SITING AND GRADING PLAN

Plan No. **BLOCK 56** Street Name **SCHMELTZER CRESCENT**

Royal Pine Homes / Centerfield Properties Inc - 216102
"OAKRIDGE MEADOWS", RICHMOND HILL, ON

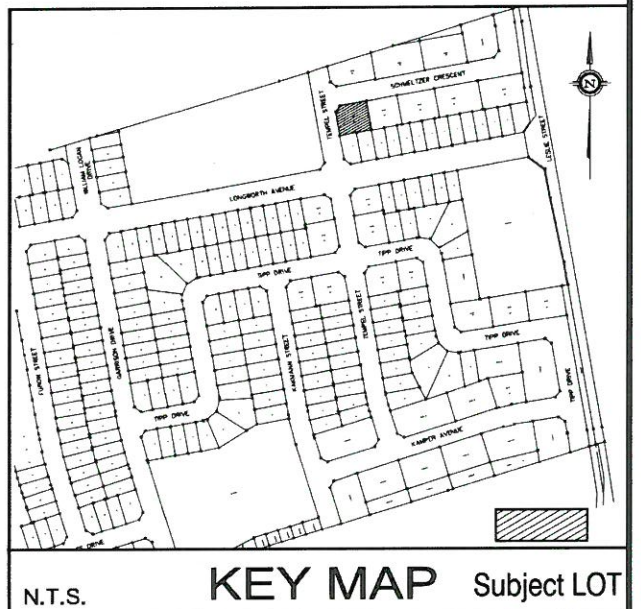
No unprotected openings permitted within 1.2 meters of the lot line as per article 9.10.14 of the Ontario Building Code.

As per OBC 2012, Div.B, 9.10.14.5(5), projections such as balconies, eaves, stairs, etc., that are more than 1m above grade, shall be non-combustible when within 1.2m of a property line or 2.4m of a combustible projection on another building on the same property.
